CITY OF ALBUQUERQUE

RE: Uptown Connect Mixed Use 2121 Indiana St NE Conceptual Grading & Drainage Plan Engineer's Stamp Date: 9/15/25 Hydrology File: H18D076 Case # HYDR-2025-00331

Based upon the information provided in your submittal received 09/15/2025, the Conceptual Grading & Drainage Plan **is approved** for action by the Development Facilitation Team (DFT) on Site Plan for Building Permit or for action by the Development Hearing Officer (DHO) on Preliminary Plat.

CG100

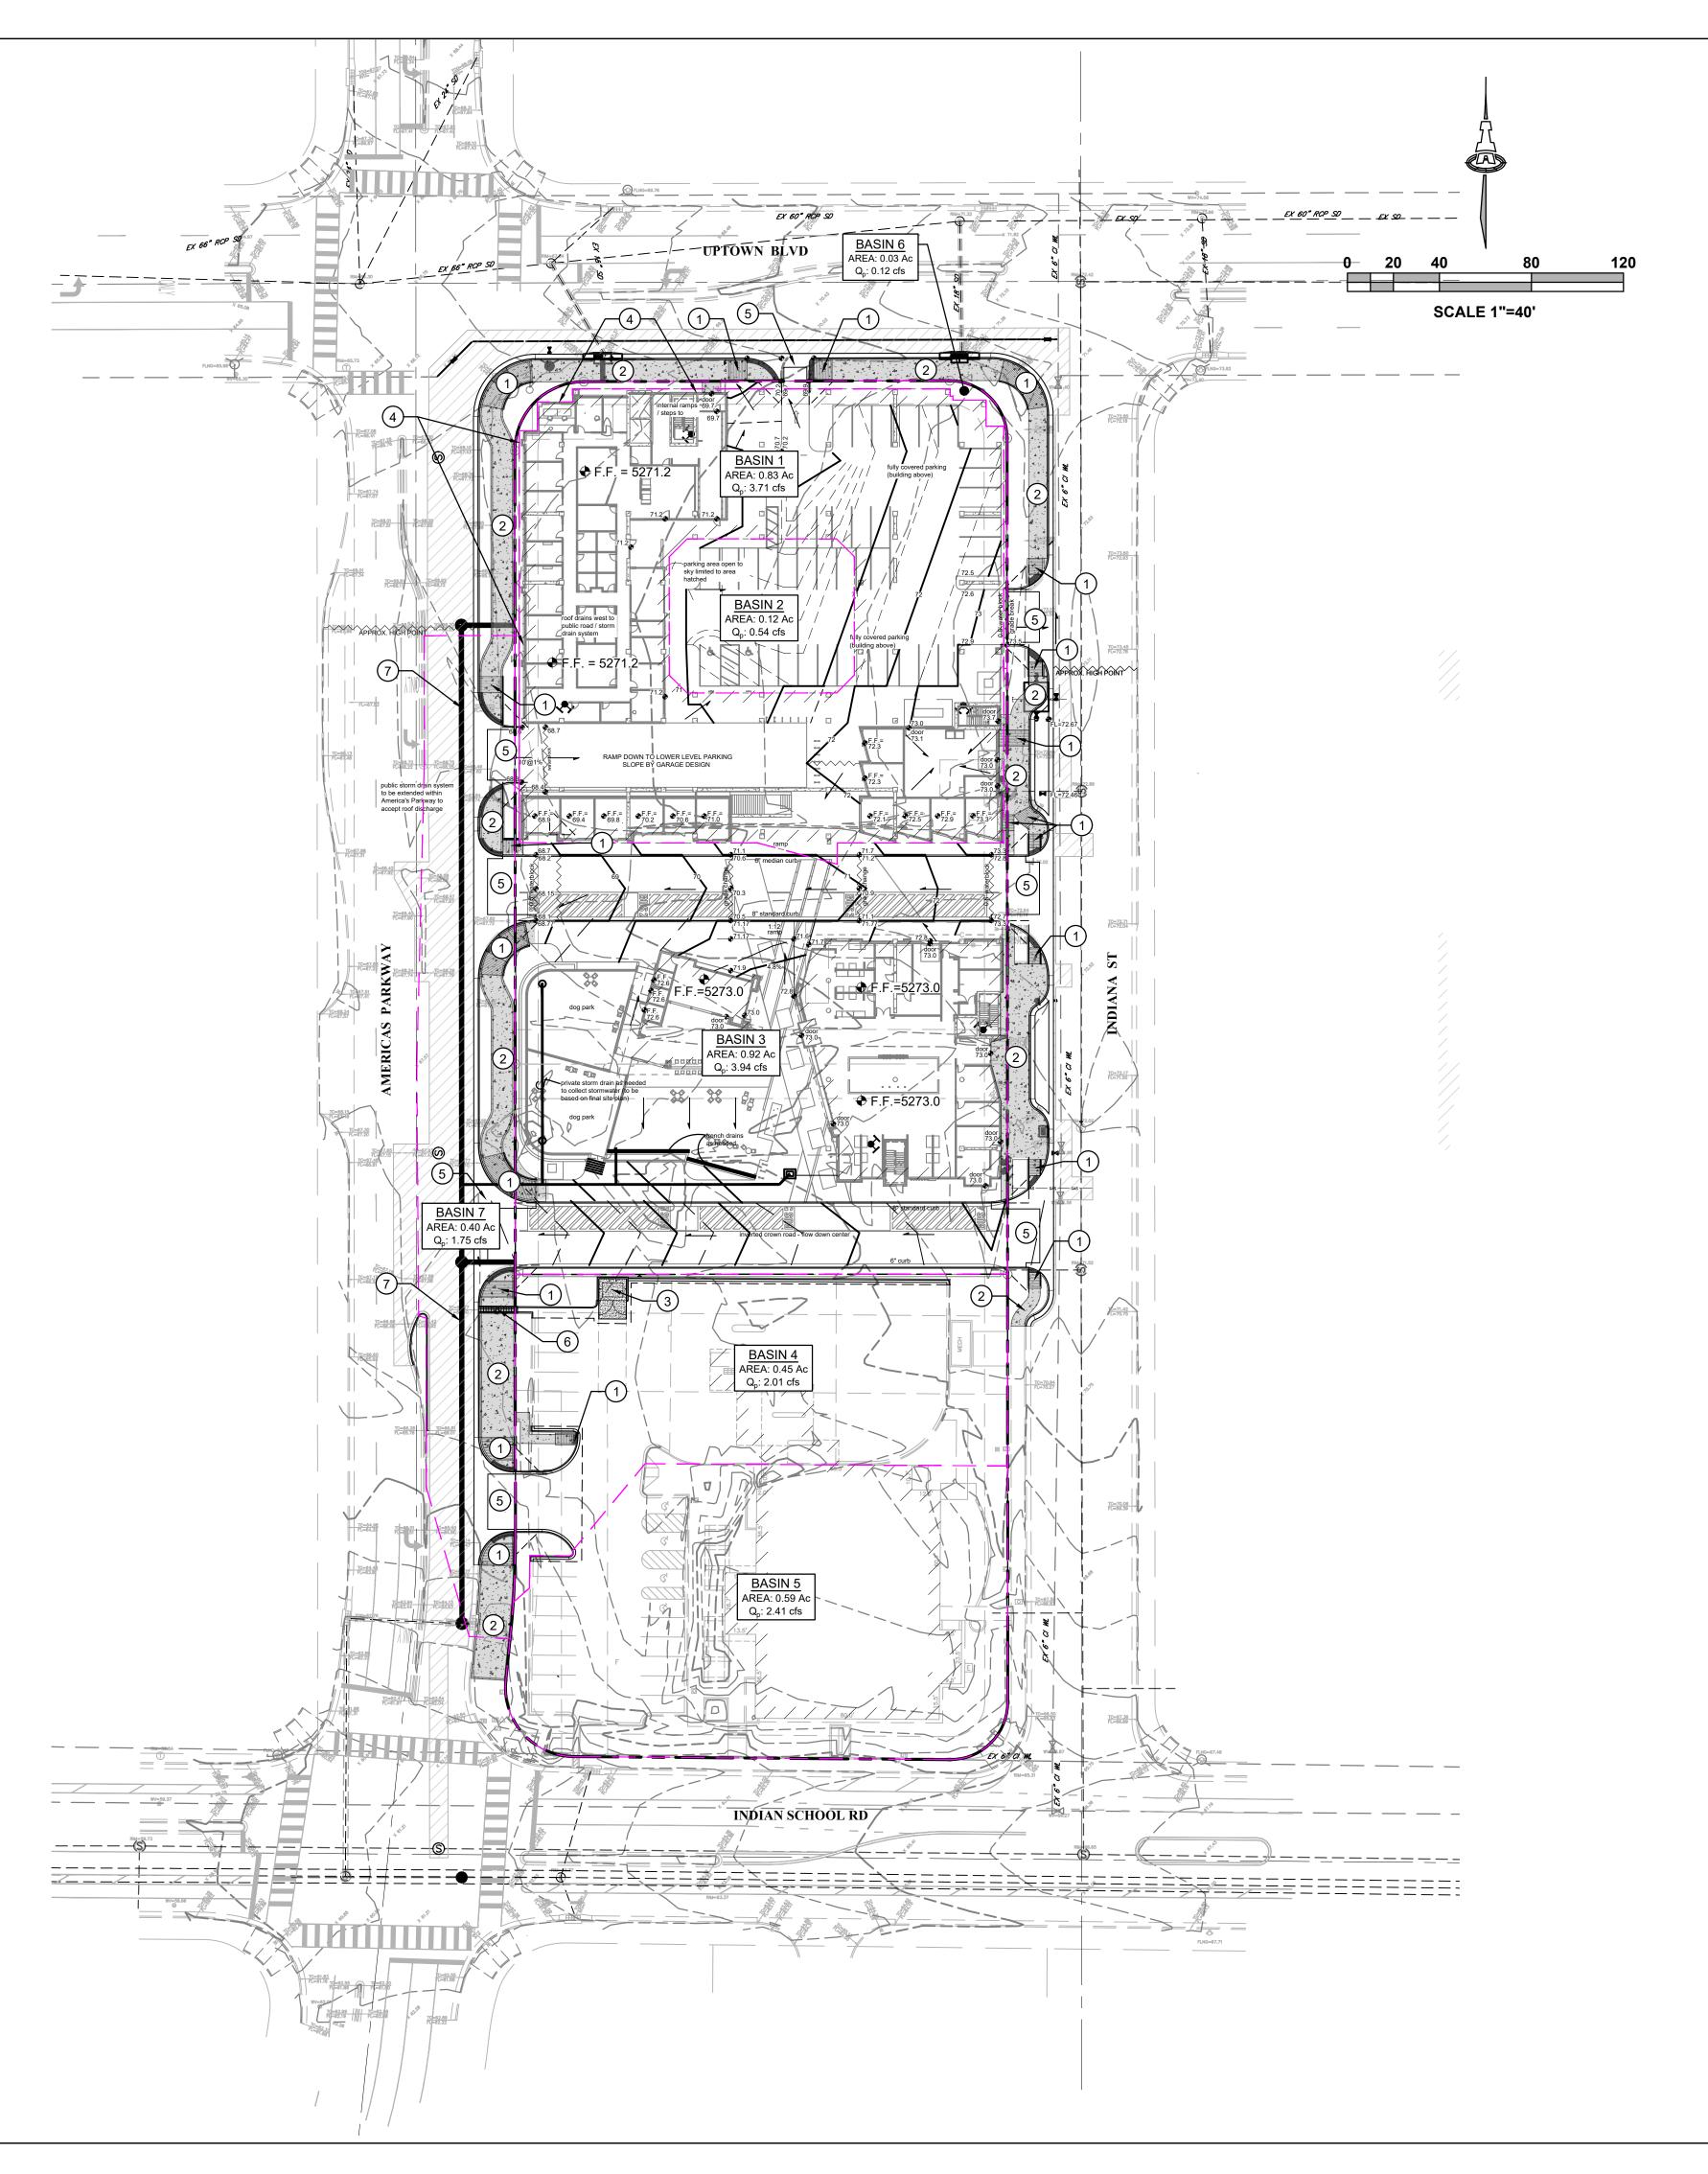
1. Please submit a more detailed Grading & Drainage Plan to Hydrology for review and approval.
